CT7-2E1 ALERT SERVICE BULLETIN - 72- A0034 R01

**SB 72-A0034 R01 ENGINE - POWER TURBINE MODULE (72-50-00) - POWER TURBINE SHAFT /TORQUE REFERENCE TUBE MAGNETIC INSERT BRAZE INSPECTION**

REVISION 1 TO ALERT SERVICE BULLETIN 72-A0034

Revision 1 is issued to update the minimum allowable braze coverage requirement and add an additional procedure to review /update documentation for engines inspected to the 42% braze coverage requirement.

C-Sump Heat Shield and C-Sump Cover - Removal and Installation  
 Figure 1

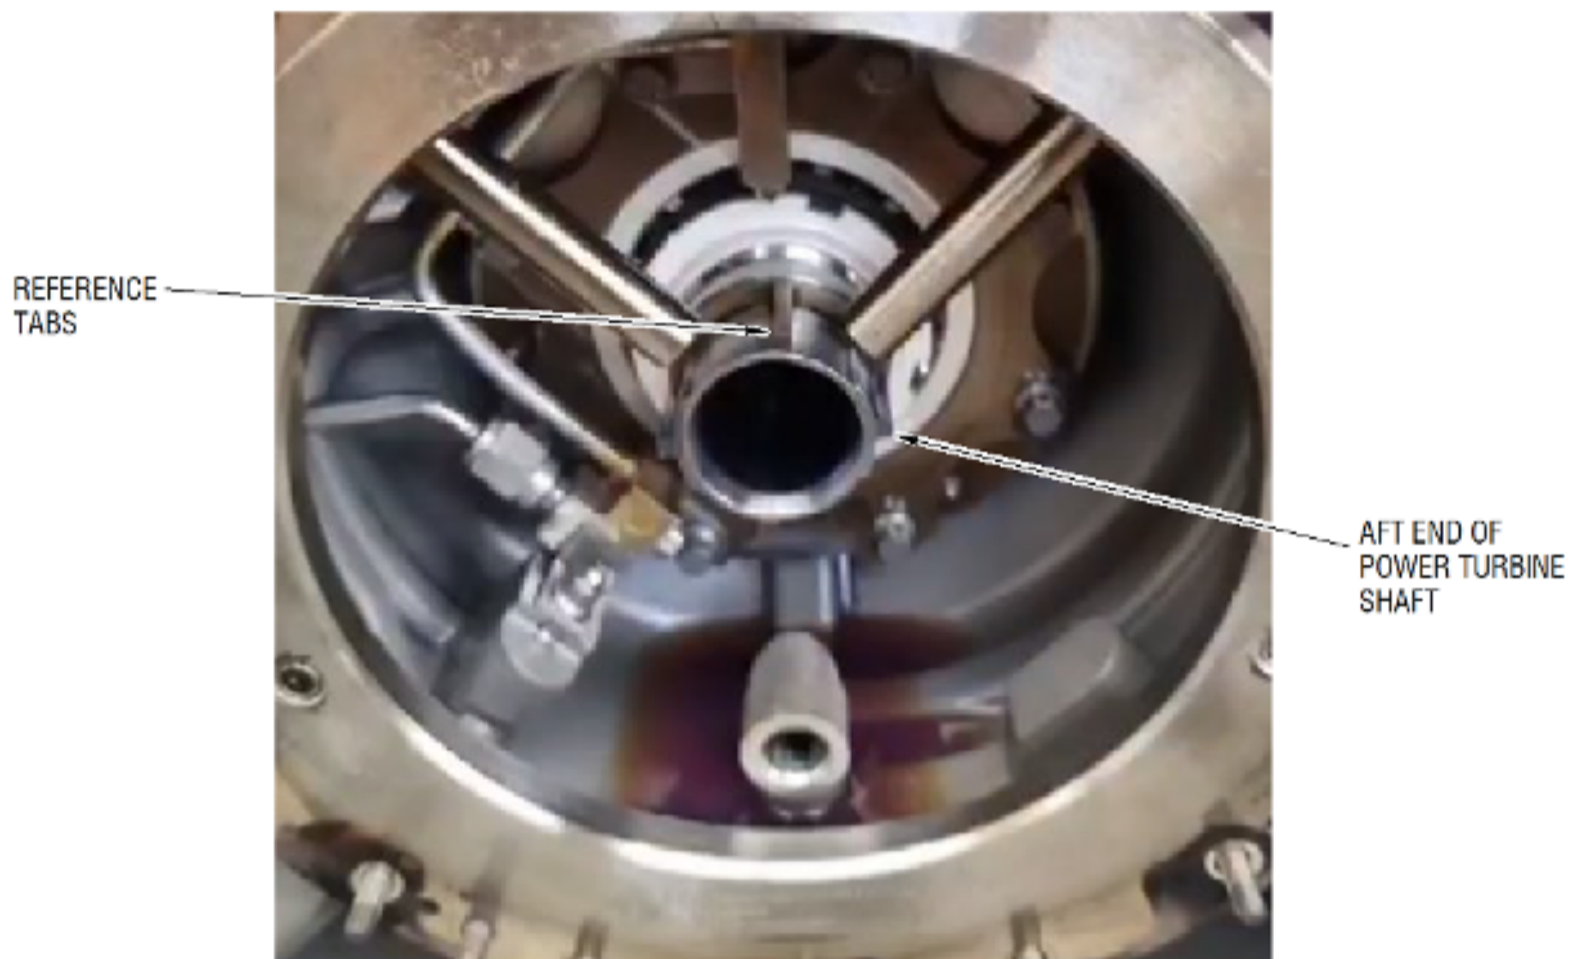
- (2) Remove the C-sump heat shield (01-020, [Figure 1](#)) and C-sump cover (01-040). Refer to CT7-2E MM GEK 112043-02, 72-50-00, REMOVAL AND INSTALLATION, TASK 72-50-00-400-801, paragraph 4.A.

- (4) Once the inspection is completed, re-install the C-sump cover (01-040, [Figure 1](#)) and C-sump heat shield (01-020). Refer to CT7-2E MM GEK 112043-02, 72-50-00, REMOVAL AND INSTALLATION, TASK 72-50-00-400-801, paragraph 4.B.(3)

C-Sump and Aft End of Power Turbine Shaft  
Figure 2

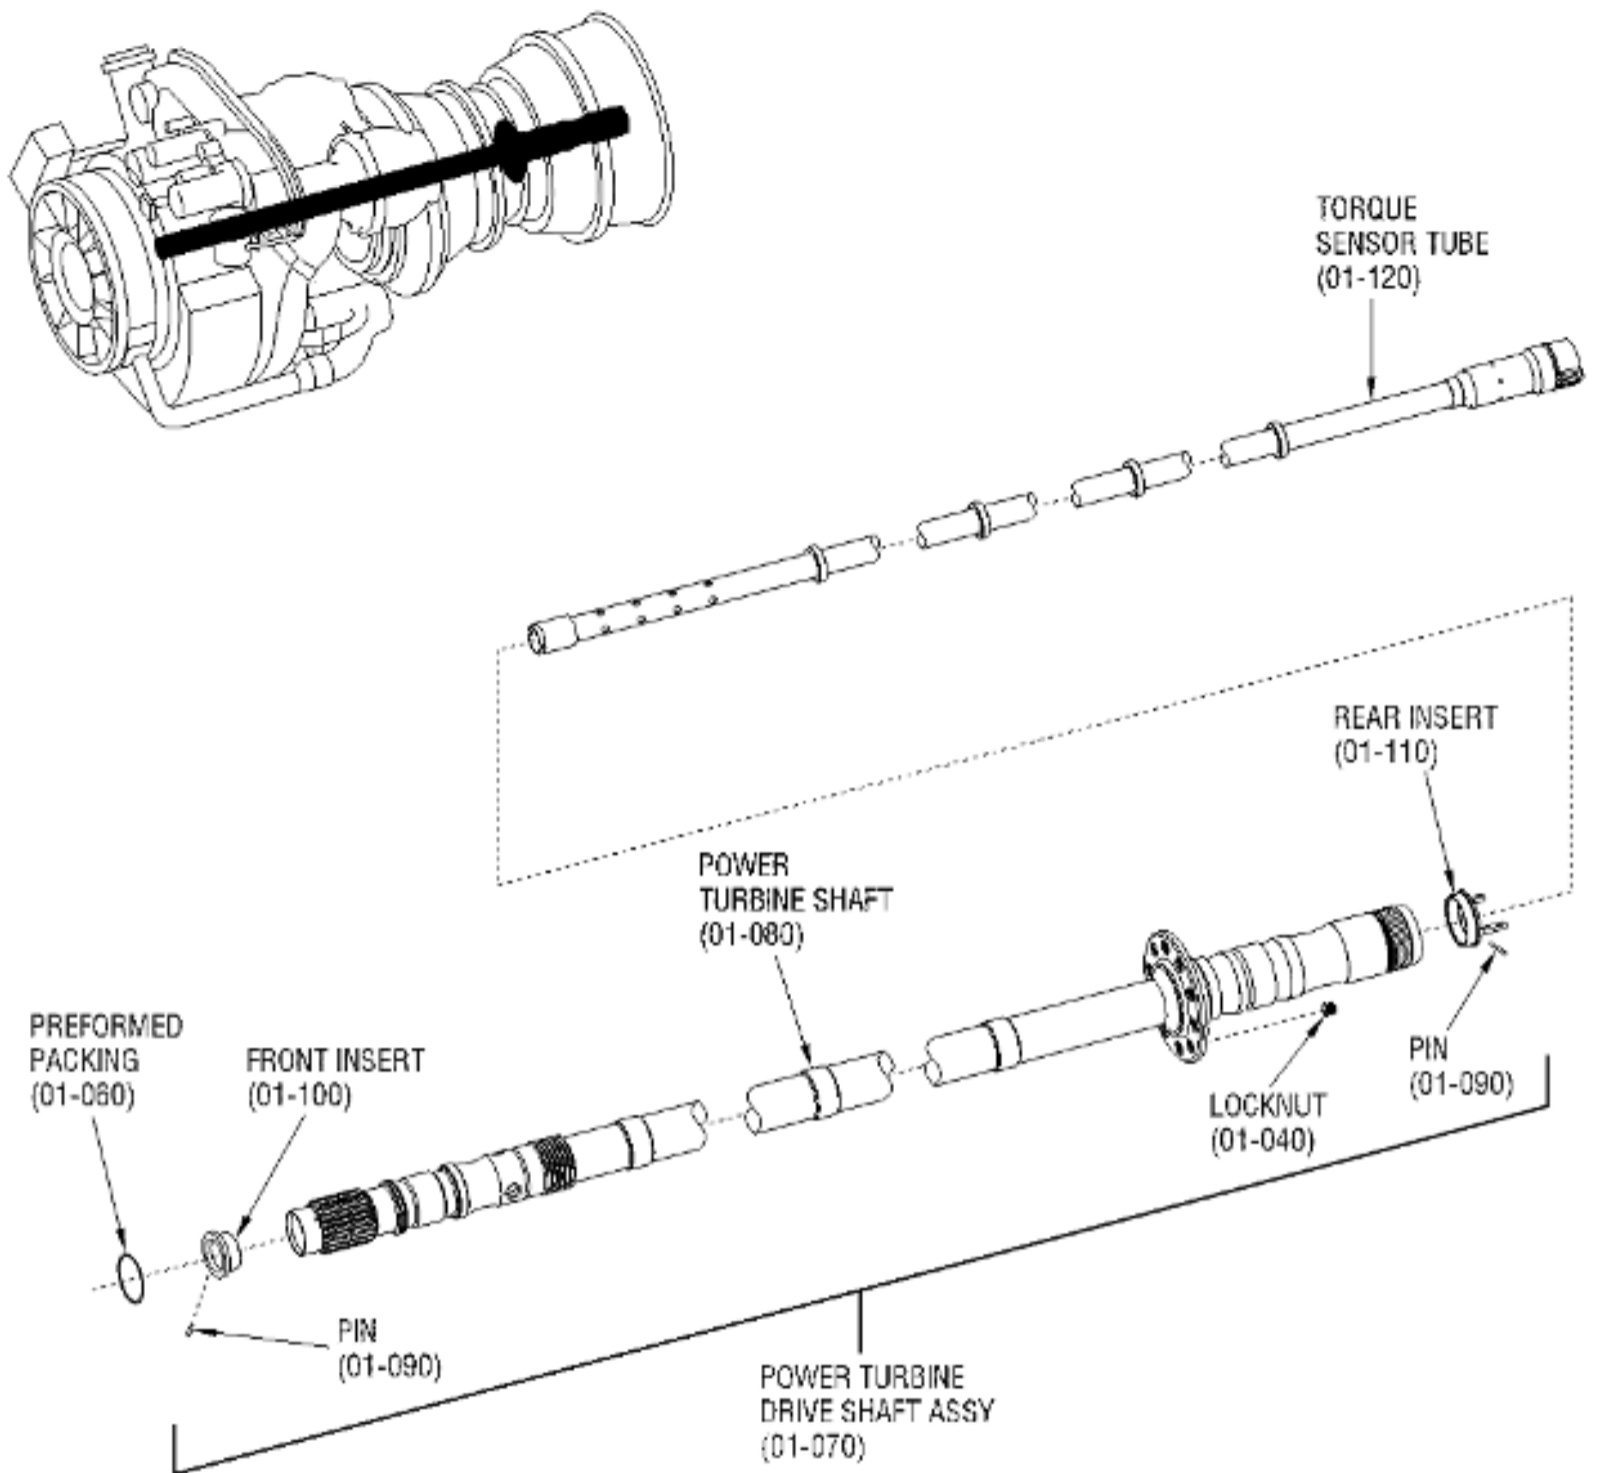
NOTE: Review the engine log book for the installation time of the installed PT drive shaft assembly P/N [5125T92G01](#). If the current operational time on the part since installation is over 100 hours, compliance with this Alert Service Bulletin is satisfied. Go to paragraph 3.B.(3) and record compliance with this Alert Service Bulletin. If the PT drive shaft assembly is less than 100 hours, proceed with the remainder of this Alert Service Bulletin.NOTE: This procedure gives instructions to remove the C-sump heat shield (01-020, [Figure 1](#)) and C-sump cover (01-040) to inspect the magnetic insert braze joint on the PT drive shaft assembly (01-070, [Figure 2](#) and [Figure 3](#)).
